Request for Additional Information (RAI) on:

1. EPRI Report 1012044 and 1012045, "Assessment of a Performance-Based Approach for Determining Seismic Ground Motions for New Plant Sites, VI and V2" (G1.1)
2. EPRI Report 1012965, "Use of CAV in Determining Effects of Small Magnitude Earthquakes on Seismic Hazard Analyses" (G1.2)
3. EPRI Report 1013105, "Truncation of the Lognormal Distribution and Value of the Standard Deviation for Ground Motion Models in the Central and Eastern United States" (G1.3)
4. EPRI Report 1012966, "Effect of Seismic Wave Incoherence on Foundation and Building Response" (S2.1a)
5. EPRI Report 1012968, "Spatial Coherency Models for Soil-Structure Interaction" (S2.1b)
6. EPRI Report 1012967, "Effect of Negligible Inelastic Behavior on High Frequency Response" (S2.2)
7. NRC staff questions from the October 19-20, 2005 meeting with industry on Seismic Issues Resolution Program

Figure I-1. Layout of foundation and coordinate system (from Luco and Wong, 1986).

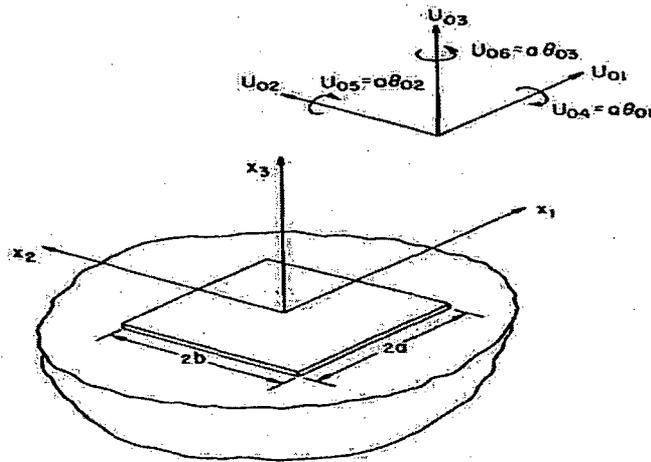
- 4.51 A previous analysis by Luco and Wong (1986) evaluated the response of a rectangular, rigid, massless foundation subjected to spatially random ground motions. Because their analysis and results are closely related to those presented in this report, their work is briefly described herein for clarity in this question.
- 4.52 Figure I-1 presents the layout and coordinate system of the Luco and Wong analyses. It is considered that the rectangular ($2a \times 2b$) massless, rigid foundation is bonded to a visco-elastic half-space with Poisson's ratio of $1/3$ and material damping ratio of 0.01 .

Figure I-2. Comparison of the Abrahamson and the Luco and Wong coherency models at separation distances of 10 m and 45.75 m (= 150 ft).

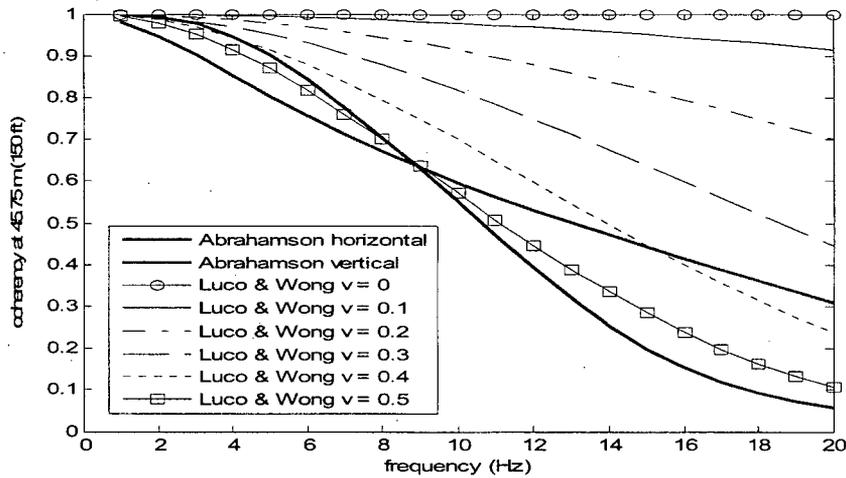
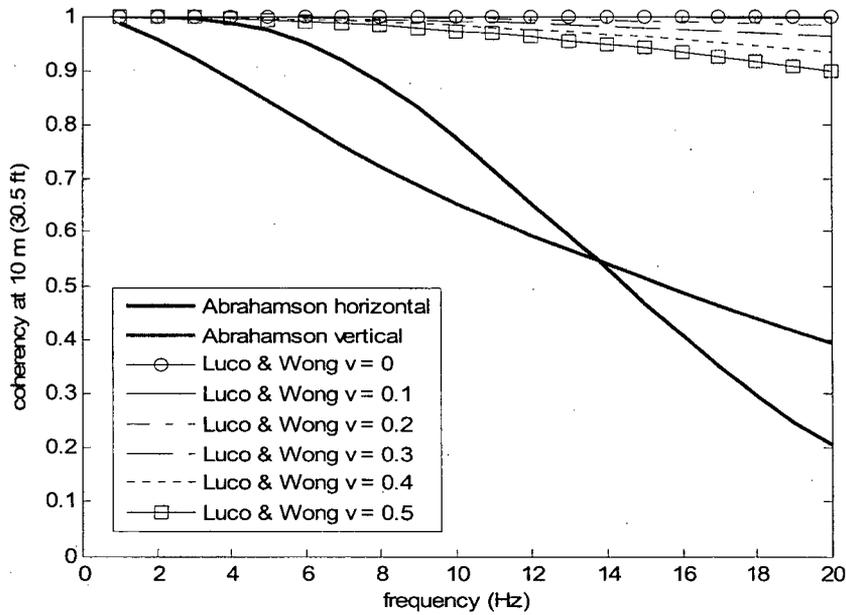
0.5 falls in-between the horizontal and vertical Abrahamson models. At longer separation distances, the Luco and Wong model falls off more sharply with frequency than the Abrahamson models.

Figure I-3. Foundation response to seismic ground motions exhibiting loss of coherence (from Luco and Wong, 1986). The coherency drop parameter " γ " in the figure is referred to in the text as " ν " because " γ " in the EPRI reports refers to the coherency function.

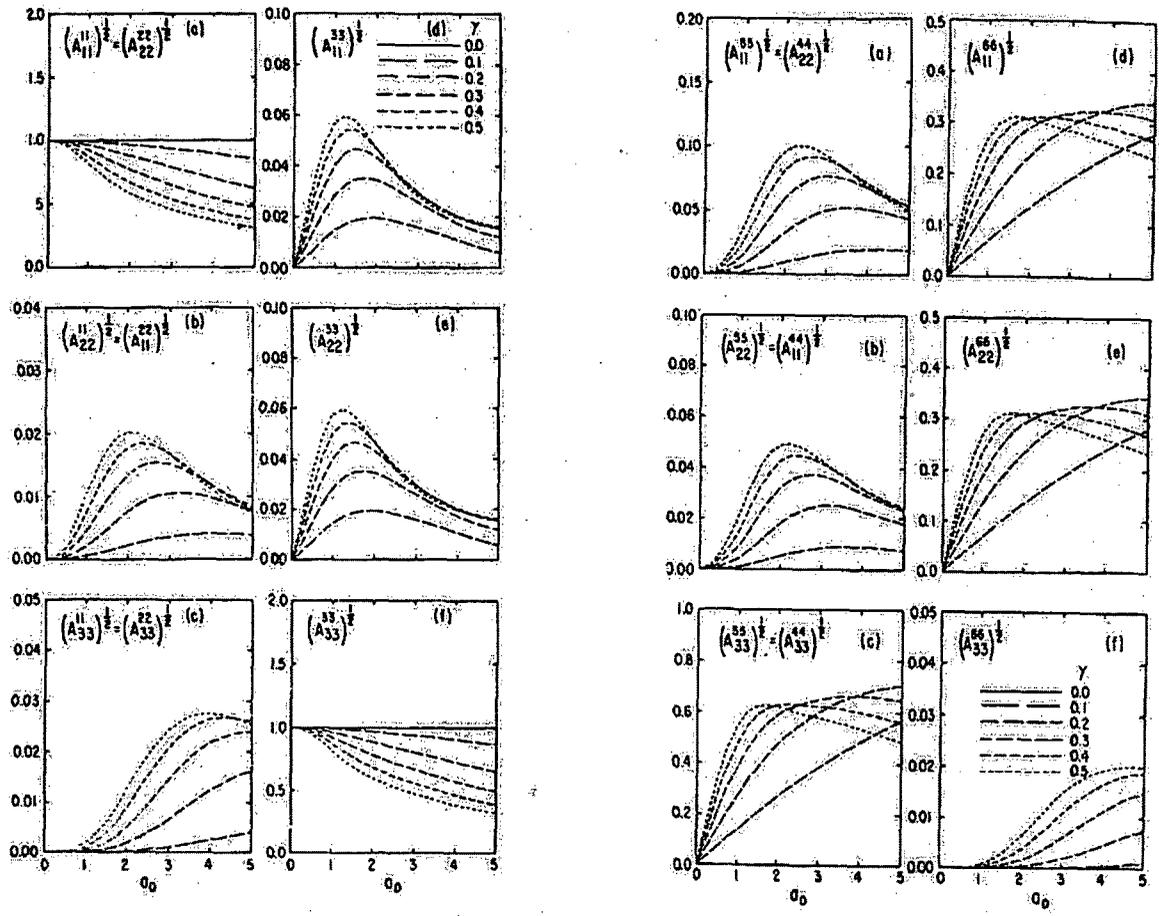
Figure I-3b indicates that rocking caused by the vertical motions (subfigure (c)), and torsion caused by the horizontal motions (subfigures (d) and (e)) can be significant, and increase as ν increases (and coherency decreases, Fig. I-2). It is also noted from Fig. I-3b, subfigures (c), (d) and (e), that as ν increases, the peaks of $\sqrt{A_{33}^{44}}$, $\sqrt{A_{33}^{55}}$, $\sqrt{A_{11}^{66}}$ and $\sqrt{A_{22}^{66}}$ shift towards the lower frequencies. On the other hand, the negligible effect of rocking discussed on p. 6-10 of the EPRI report appears to be counter-intuitive, in that the large reductions in the translational response due to incoherency presented in the report do not result in any rotational effects. Since the Abrahamson coherency model drops more rapidly with frequency and separation distance than the Luco and Wong model (Fig. I-2), this should lead to even higher values for the rotational transfer functions, but it is stated in the report that their effect is negligible. Does the rotational effect become

Figure II-1. Comparison of the coherency decay recorded at the LSST array (event 12) and the SMART-1 array (event 43) (from Abrahamson *et al.*, 1991).

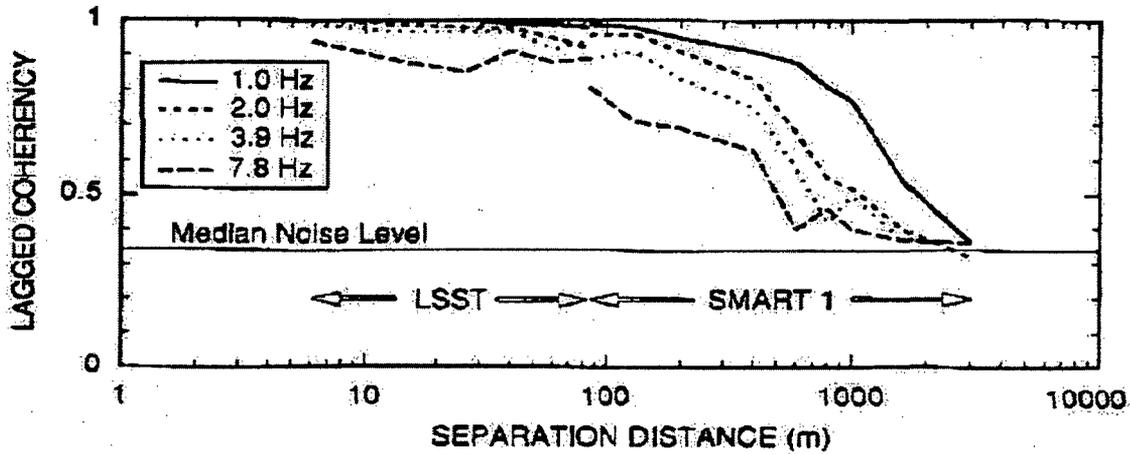
- 5.16 It has been observed that there is a difference in the pattern of the coherency decay at shorter and longer separation distances (i.e., coherence decay is dependent on separation distance). For example, Figure 1, taken from Abrahamson *et al.* (1991), depicts the differences in the coherency decay recorded during the same earthquake at the LSST array (event 12) and the SMART-1 array (event 43); the event’s characteristics were $m_b=5.6$, depth 2 km, and its distance from the array 4 km. Abrahamson *et al.* (1991) observed that, “In general, the coherencies predicted at short station spacing using the SMART-1 coherency functions are larger than measured from the LSST array. This is especially true at frequencies greater than 5 Hz”. Riepl *et al.* (1997) made a similar observation from their analyses of an extensive set of weak motion data recorded at the EUROSEISTEST site in northern Greece: the loss of coherence with distance for their data was marked by a “cross over” distance, that distinguished coherency for shorter (8-100 m) and longer (100-5500 m) separation distances. Can a single expression for the coherency reasonably represent the different exponential decay observed at long and short separation distances?

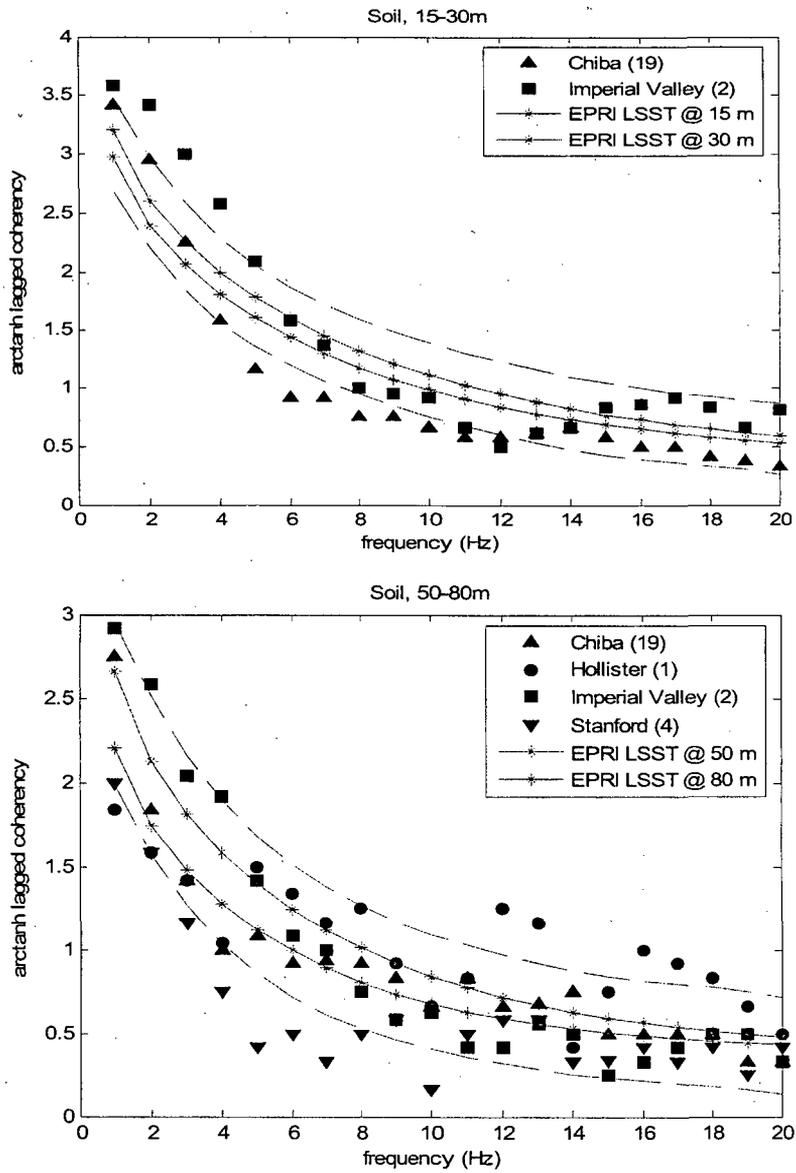
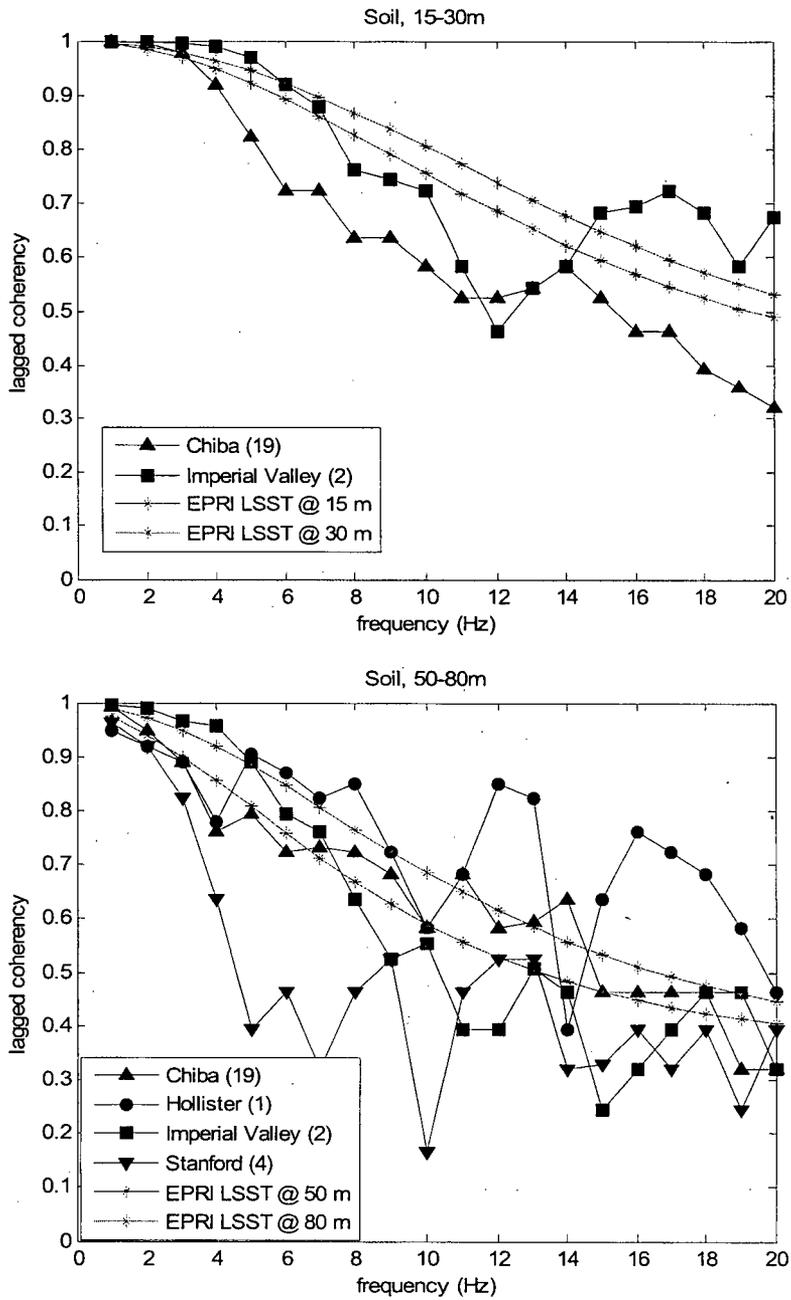
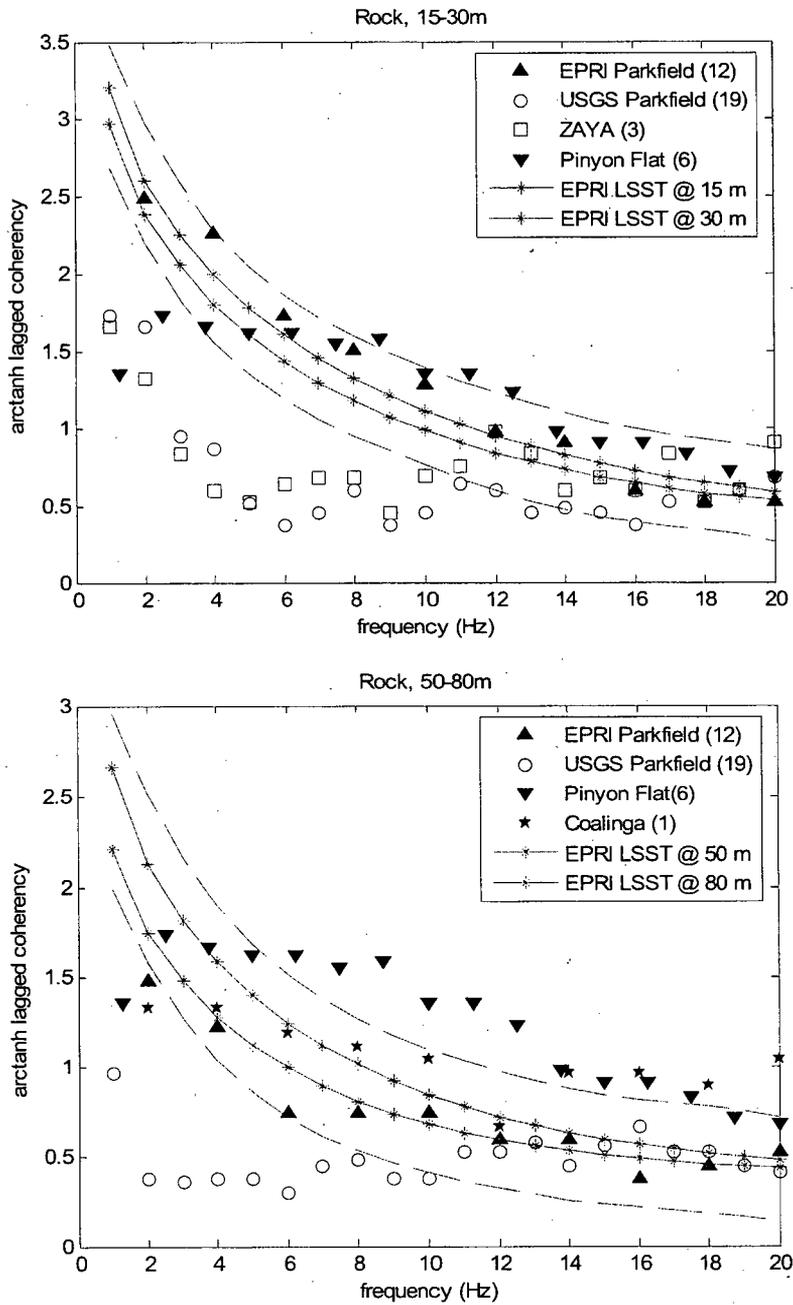
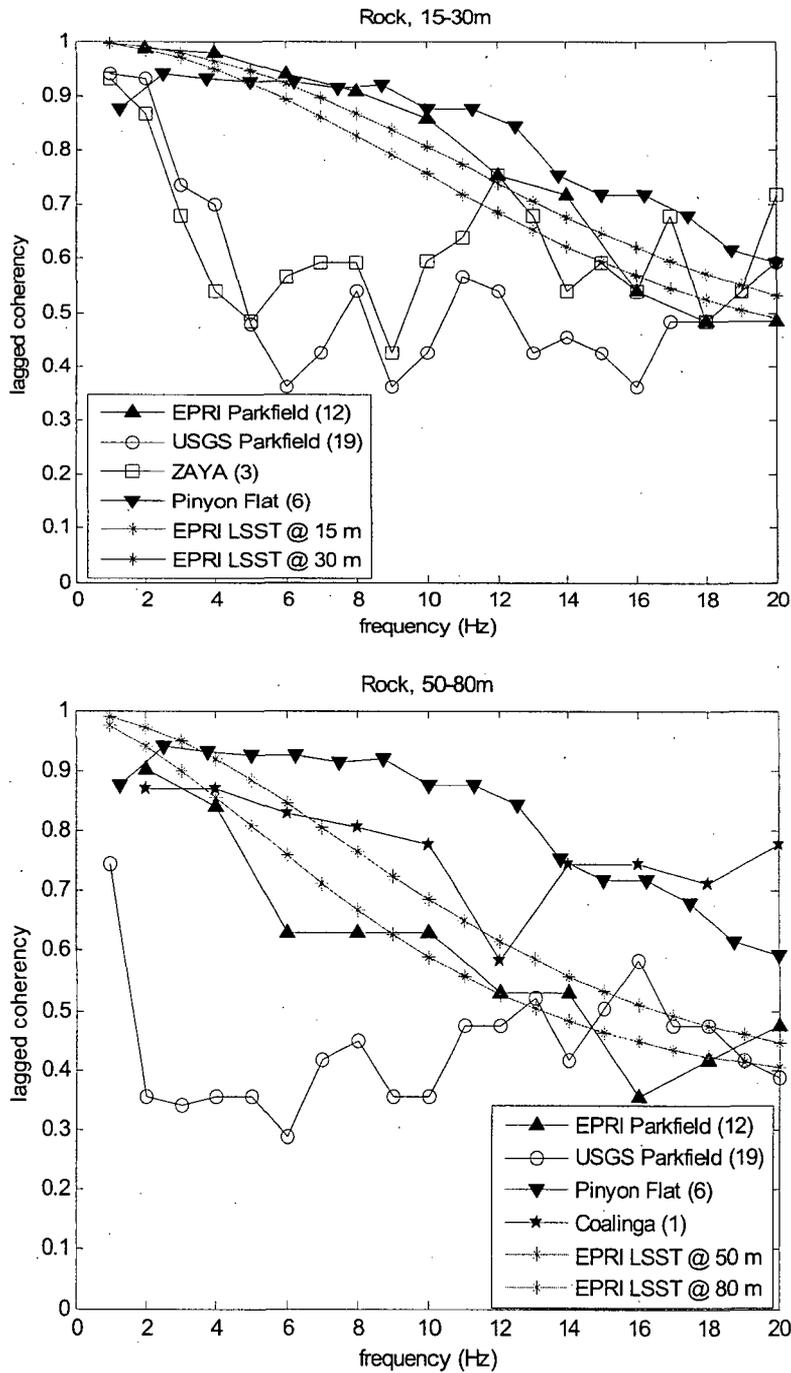
The following questions then arise, given the "flatter" and "slower" decay of the rock sites in Figs. II-4 and II-5: If the rock sites were considered by themselves, would the resulting "rock" coherency model compare well with the EPRI LSST/new coherency models? Furthermore, since the number of soil arrays/events is significantly higher than that of the rock arrays/events (as indicated in II-3), can it be that the trend of the data at the rock sites is "buried" within that of the soil sites? Also, what was the frequency content of the motions for each event? What was the frequency range for which a predominant slowness was identified from the data? Why were some recorded events not considered in the evaluation of the new coherency model? For example, from the 15 events recorded at EPRI LSST (Abrahamson *et al.*, 1991) 13 were used for the new model, and from the 12 events recorded at EPRI Parkfield and the 19 events at Chiba (Abrahamson *et al.*, 1992) only 2 and 9 events, respectively, were used for the new model (Table II-1).

Figure II-9. Normalized power spectral densities at soil and rock sites and EPRI LSST lagged and plane-wave coherency at separation distances of 10, 30, 60 and 100 m.

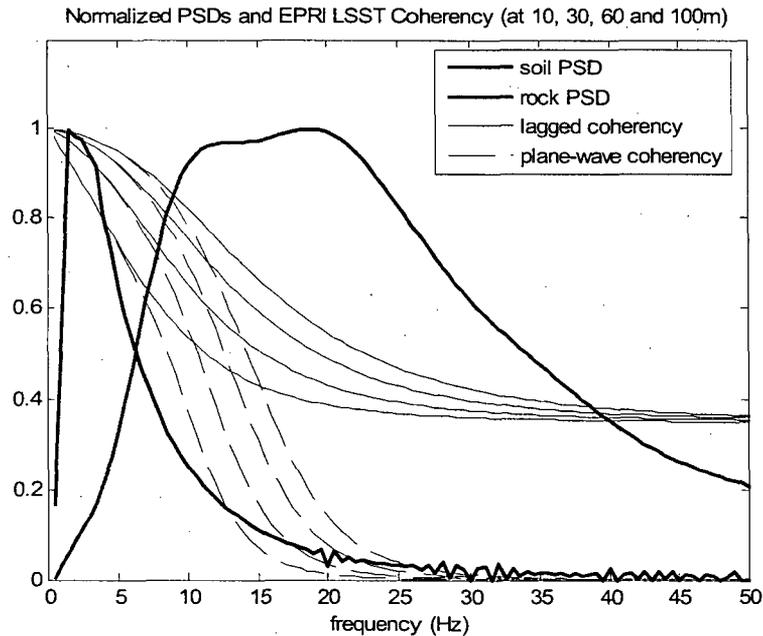
Figure II-9 presents the normalized PSDs for soil and rock and the EPRI LSST lagged and plane-wave coherencies at separation distances of 10, 30, 60 and 100 m. The plane-wave coherency (Eq. II-3) can be used to model the wave field by a single inclined plane wave (Abrahamson *et al.*, 1991). The plane-wave coherency in Fig. II-9 decays sharply passed the dominant frequency range of the soil PSD. However, it decays sharply from the beginning of the dominant frequency range of the rock PSD. Does this imply that a very significant part of the dominant frequency range of the rock sites cannot be considered as a single inclined wave but energy coming from different paths?

Figure II-10. Comparison of the EPRI Parkfield coherency of a small event with the LSST coherency for (A) 10 m and (B) 60 m station separation distance (from Schneider *et al.*, 1990).

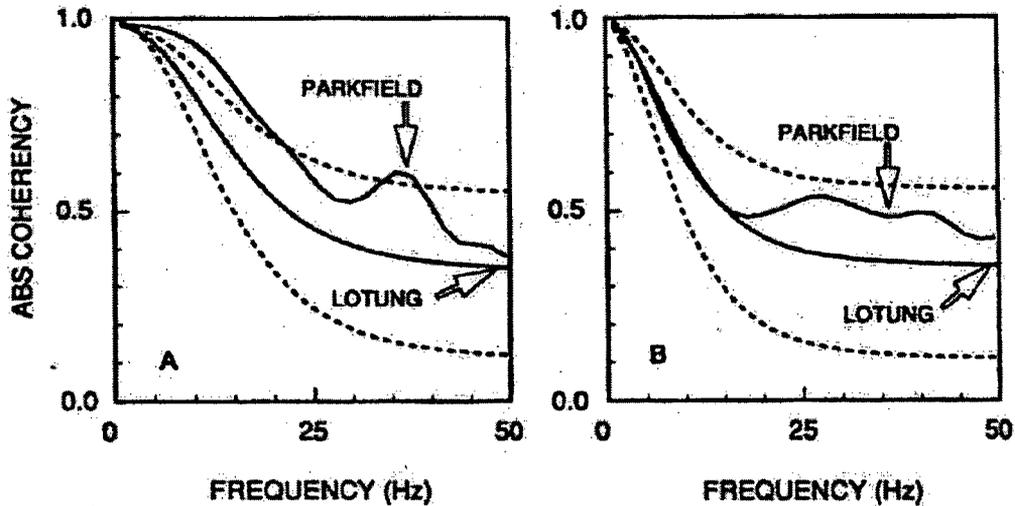
- 5.19 A previous study (Schneider *et al.*, 1990) analyzed a small (M 3) earthquake recorded at the EPRI Parkfield array and compared it with the Lotung coherency. The epicentral distance of the earthquake was 9 km from the array and its depth was 9 km. The EPRI Parkfield array site is characterized as soft rock (Table II-1). Figure II-10, taken from Schneider *et al.* (1990), presents the comparison of the EPRI Parkfield coherency for the small event with the median and 16th and 84th percentile LSST coherency for separation distances of 10 m and 60 m. Even though the EPRI Parkfield coherency falls within the 16th and 84th percentile LSST coherency (except at low frequencies for the 10 m separation distance), there is an observable increase in the single-event EPRI Parkfield coherency past 20 Hz. The type of behavior at higher frequencies indicated in Fig. II-10 cannot be extrapolated from the exponential decay at the lower frequencies. Are there additional data available at such high frequencies? Is a similar trend observed for other sites/events?

Figure II-11. Figure 3-3 from EPRI report

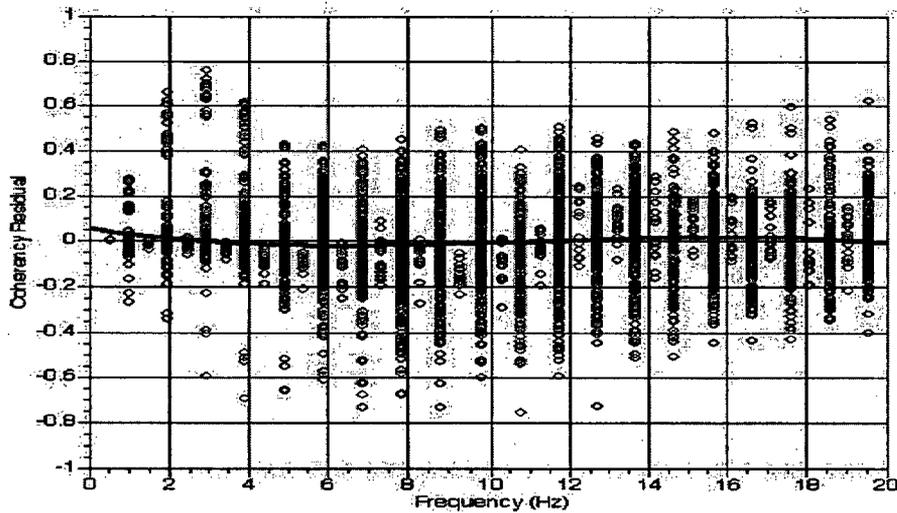
5.20 In the comparison of residuals of the arctanh plane-wave coherency of Fig. 3-3 of the EPRI report, reproduced here in Fig. II-11: There appears to be an array (or arrays), for which the analyzed time window permitted frequency domain transform with a frequency step of $\Delta f \approx 0.5$ Hz. The coherency residuals for these events are consistently negative at frequencies 0.5, 1.5, ..., 11.5 Hz, which suggests a negative trend for these array(s) at lower frequencies. If the data from the different arrays were distinctly presented in the figure instead of being grouped together, would there be additional observable trends?

Figure II-12. Figures 3-4 and 3-5 from EPRI report

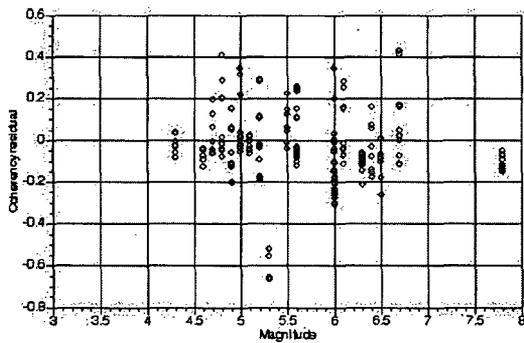
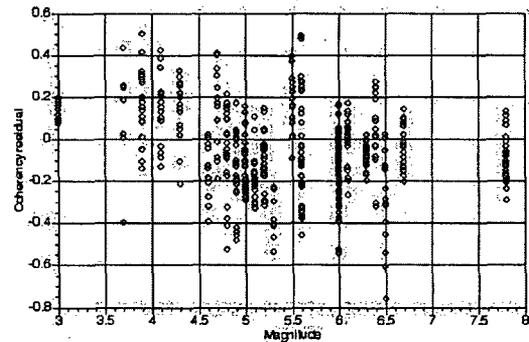
5.21 Figures 3-4 and 3-5 of the EPRI report, which present the coherency residuals as functions of magnitude at 5 Hz and 10 Hz, respectively, are combined in Figure II-12. Similarly, Figs. 3-6 and 3-7 of the EPRI report, that present the coherency residuals as functions of distance at 5 Hz and 10 Hz, respectively, are combined in Figure II-13. The 5 Hz figures are less populated than the 10 Hz ones: For example, Fig. 3-4 (in Fig. II-12) does not present any data at 5 Hz for magnitudes lower than 4.3, whereas data are presented in the 10 Hz plot (Fig. 3-5), and the number of data points at higher magnitudes appears to be less for the 5 Hz plot (Fig. 3-4) than the 10 Hz plot (Fig. 3-5). Figure 3-6 (in Fig. II-13) does not present any data at 5 Hz for distances of 6 and 9 km, whereas data are presented for the 10 Hz plot (Fig. 3-7). There are also 4 data sets at distances between 10 and 20 km for the 10 Hz plot (Fig. 3-7), but only two for the 5 Hz plot (Fig. 3-6). Again, the number of data points appears to be less for the 5 Hz plot (Fig. 3-6) than the 10 Hz plot (Fig. 3-7). Can Figs. 3-4 and 3-5 be provided with all data? If the difference in the number of data points at 5 and 10 Hz is caused by the different Δf 's in the Fourier transform of the motions at the various arrays, can data be provided over a range of frequencies centered at 5 and 10 Hz, respectively, so that the trend of the data at the lower and higher frequency can be recognized?
